Project	IEEE 802.16 Broadband Wireless Access Working Group < http://ieee802.org/16 >	
Title	Handoff SDL charts proposal	
Date Submitted	2004-03-08	
Source(s)	Itzik Kitroser Yossi Segal Yigal Leiba Zion Hadad Runcom Technologies Ltd. 2 Hachoma St. 75655 Rishon Lezion, Israel	Voice: +972-3-9528440 Fax: +972-3-9528805 mailto:itzikk@runcom.co.il mailto:yossis@runcom.co.il mailto:yigall@runcom.co.il mailto:zionh@runcom.co.il
Re:	Letter Ballot #14	
Abstract	This document presents SDL charts that describes the handoff process.	
Purpose	Integration into TGe draft.	
Notice	This document has been prepared to assist IEEE 802.16. It is offered as a basis for discussion and is not binding on the contributing individual(s) or organization(s). The material in this document is subject to change in form and content after further study. The contributor(s) reserve(s) the right to add, amend or withdraw material contained herein.

Handoff SDL charts proposal

2. Proposed changes

Figure 0h—MSS handoff locally initiated transaction begin state flow diagram

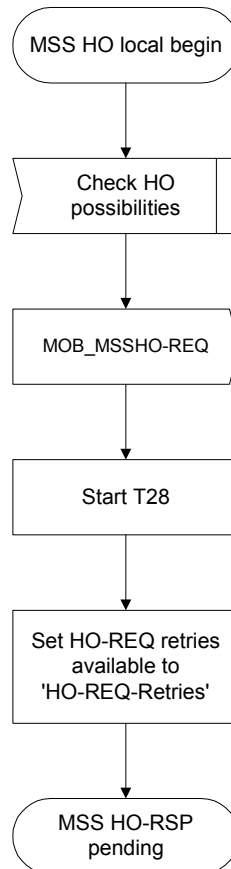
Figure 0h shows the SDL of an MSS initiating handoff with the BS.

Figure 0i—locally initiated transaction MOB_BSHO-RSP pending state flow diagram

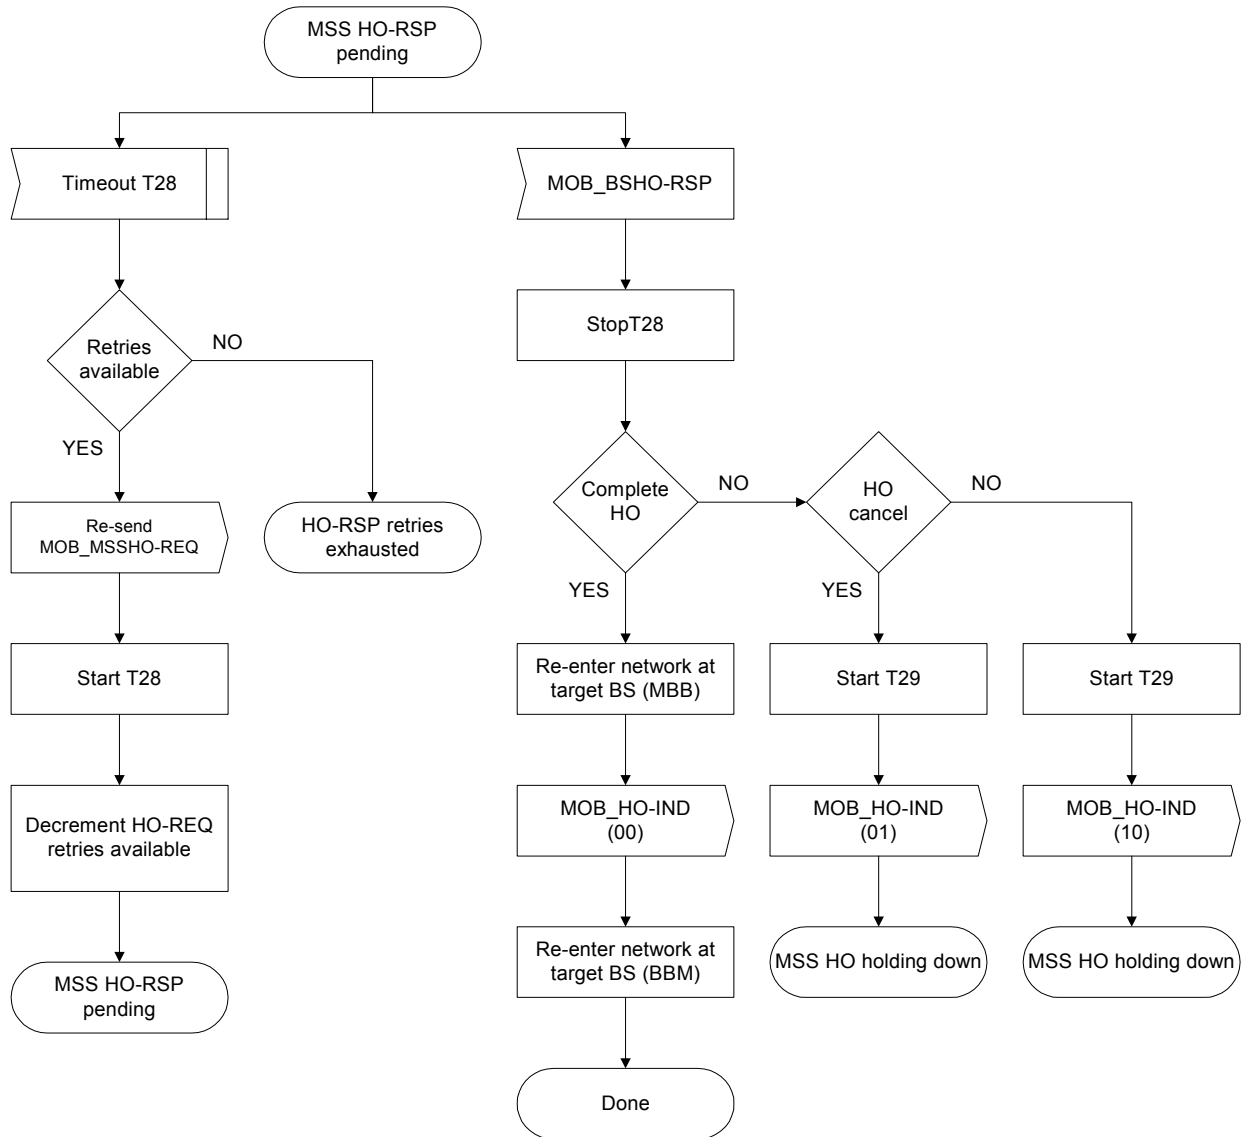
Figure 0i shows the SDL of an MSS waiting for a response from the BS, in addition it present the case in which the MSS has decided to stop the handoff in the middle of the process.

Figure 0j—MSS Handoff locally initiated transaction holding state flow diagram

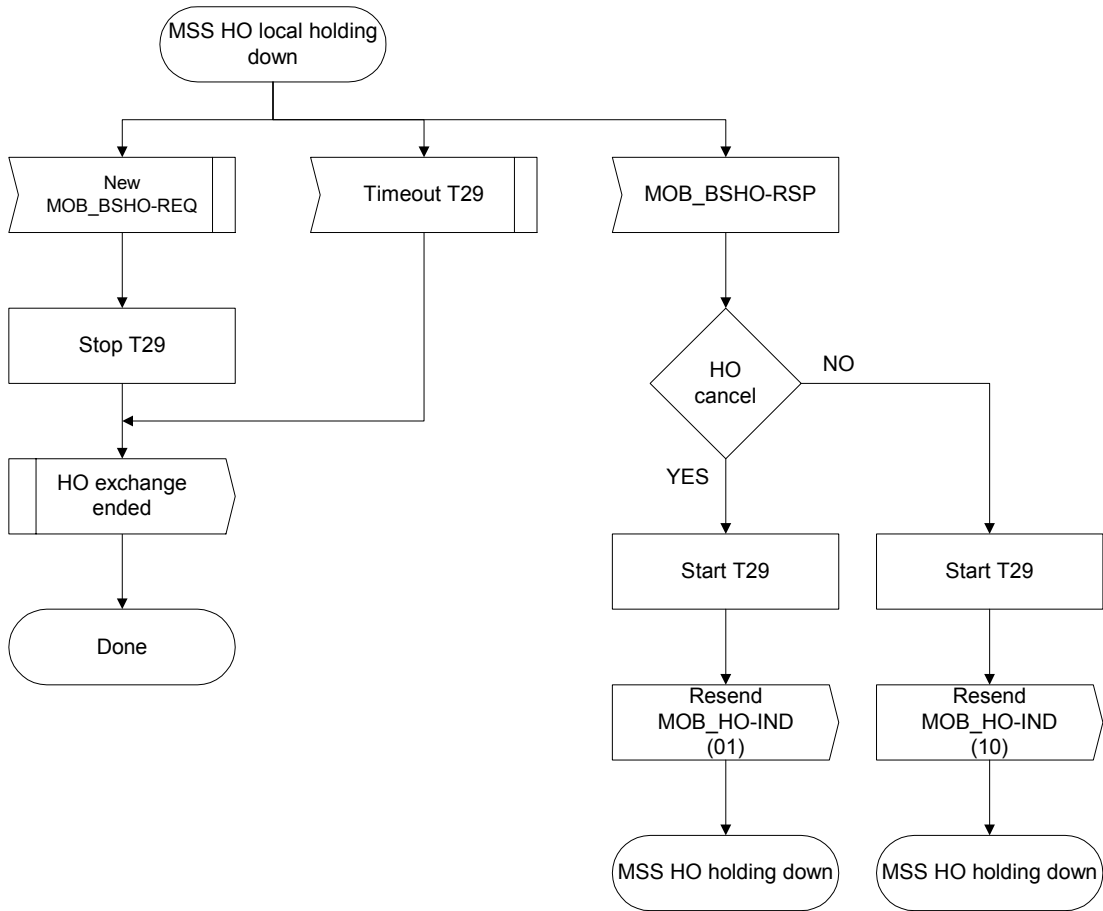
Figure 0j shows the SDL of an MSS following a canceling of the handoff and ensuring that the MOB_HO-IND message was received by the BS (by expiration of T29 timeout). While waiting, if new handoff process is required, the MSS shall stop T29 timer without waiting.

Figure 0k—locally initiated transaction MOB_BSHO-RSP pending state flow diagram

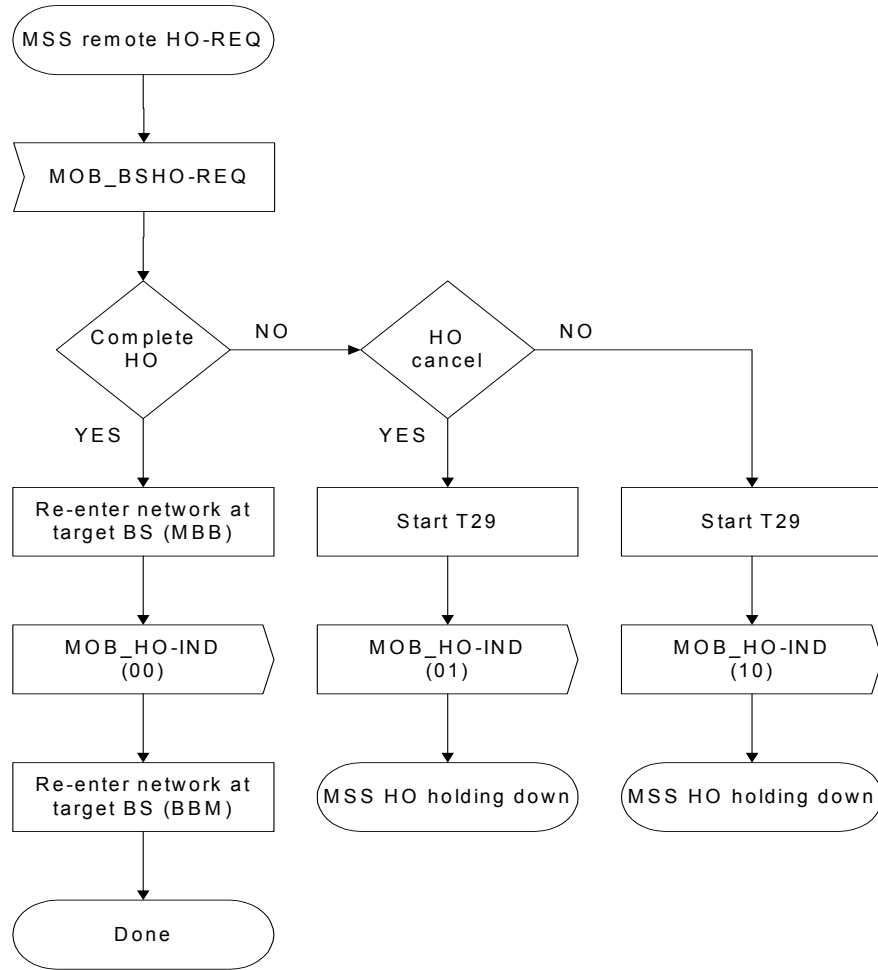
Figure 0k shows the SDL of an MSS receiving MOB_BSHO-REQ message from the BS., in addition it present the case in which the MSS has decided to stop the handoff in the middle of the process.
